Source: Leece-Neville Heavy Duty Systems Division - Arcade, NY USA  
Date: July 7, 2007  
Bulletin No: TSB-1106  
Models: MFY Starters  
Subject: Subject: MFY Starter Solenoid Change

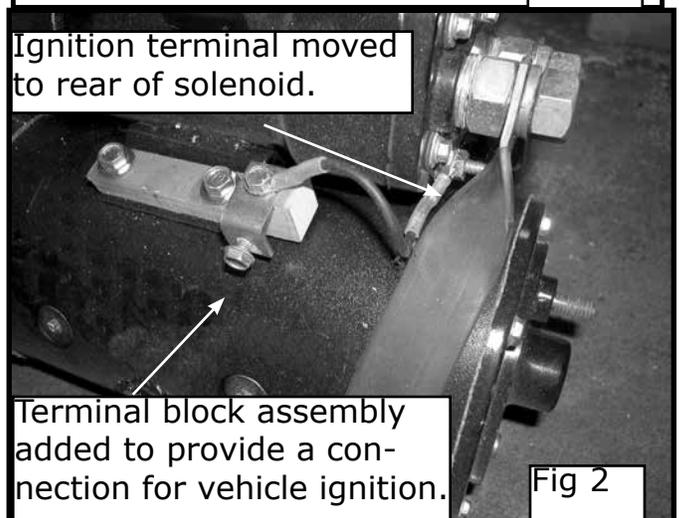
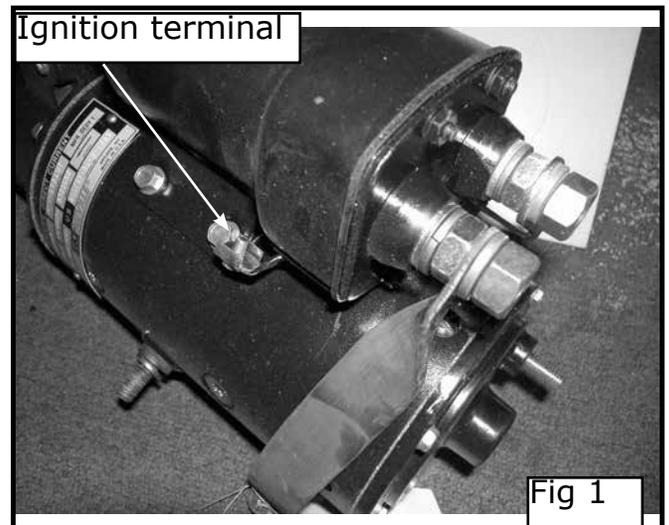
In Fig 1, shows an image of an MFY 6701UT with an SAT 4108UT solenoid.

Note the location of the ignition terminal on this starter.

The SAT 4108UT solenoid is now discontinued and replaced with the S214102585S. As you can see in Fig 2 the ignition terminal has been moved and a terminal block assembly added to provide a connection point for the vehicle ignition wire.

Note: S214102585S comes with all the hardware needed to make this conversion.
